# Service Bulletin

Bulletin No.: 10-06-01-008M

**Subject:** Engine Oil Consumption on Aluminum Block/Iron Block Engines with Active Fuel Management (AFM) (Install AFM Oil Deflector and Clean Carbon from Cylinder and/or Install Updated Valve Cover)

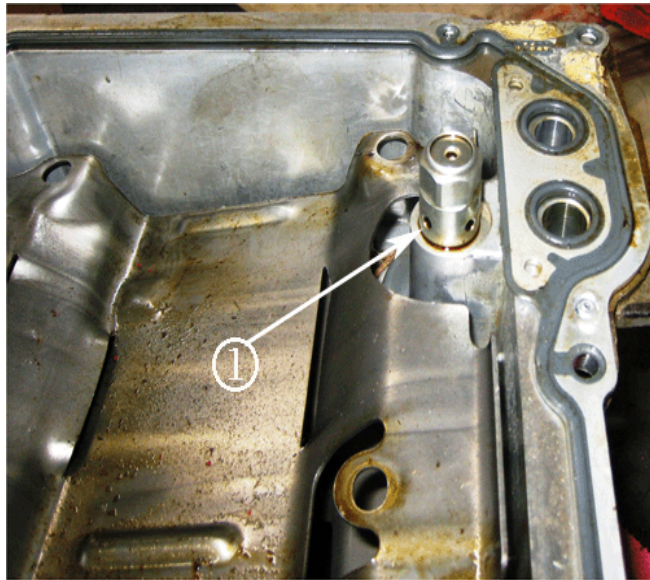
## Aluminum Block - Oil Getting Past Piston Rings - Free Up Piston Rings and Install AFM Shield on All Non-Hybrid Models

To correct this condition, install an AFM shield, perform the piston cleaning procedure as described in this document and install a new oil pan gasket per the procedure outlined in this document. Monitor oil consumption after this repair to ensure oil consumption has improved to acceptable levels.

2474205

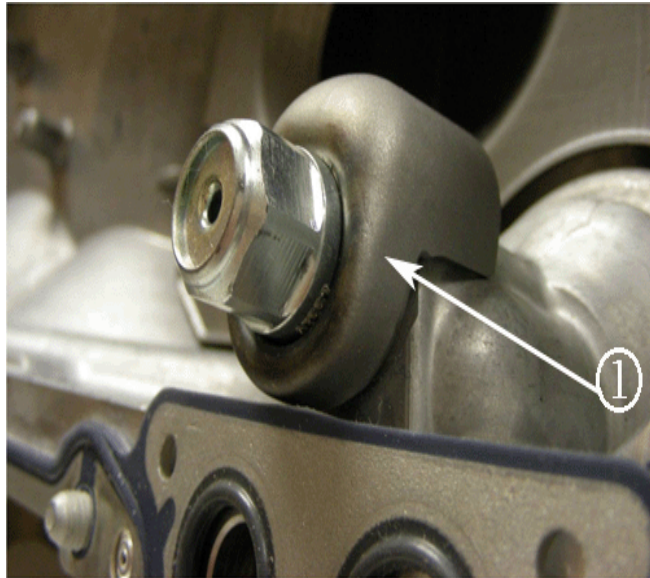
4. Remove the AFM valve (1).

5. Install the new shield (1), GM P/N 12639759, and tighten the AFM valve to the oil pan to 28 N•m (20 lb ft).

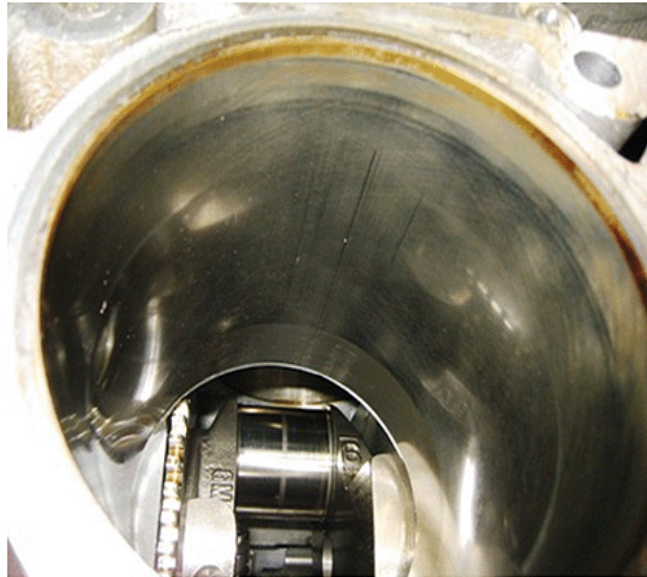
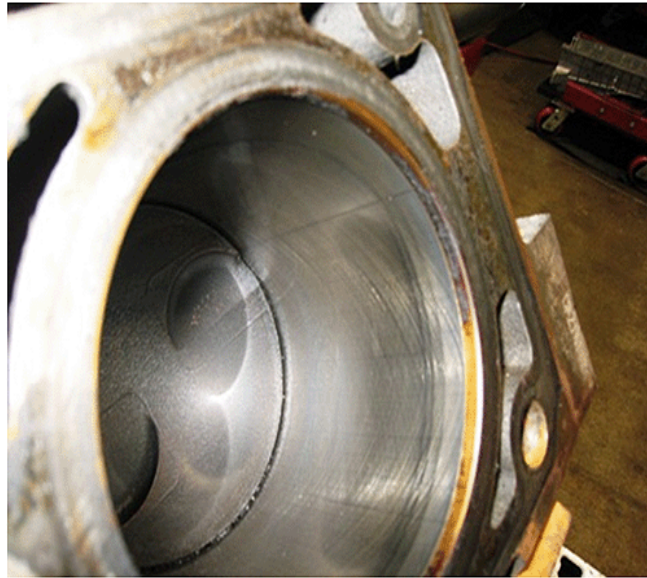
### **Cast-Iron Block - Oil Getting Past Piston Rings - Free Up Piston Rings on All Models**

1. Remove the spark plugs and ensure that none of the pistons are at top dead center (TDC).
2. Clean the pistons by putting 118-147 ml (4-5 oz) of Upper Engine and Fuel Injector Cleaner, GM P/N 88861803 (in Canada, use 88861804), in each cylinder. Allow the material to soak for at least 2.5-3.0 hours, but no more than three hours and then remove the cleaner. A suggested method of removing the cleaner is cranking the engine over. Make sure to unplug the ignition coils and fuel injector before cranking the engine over. Also make sure that the painted surfaces are covered so no damage is done.
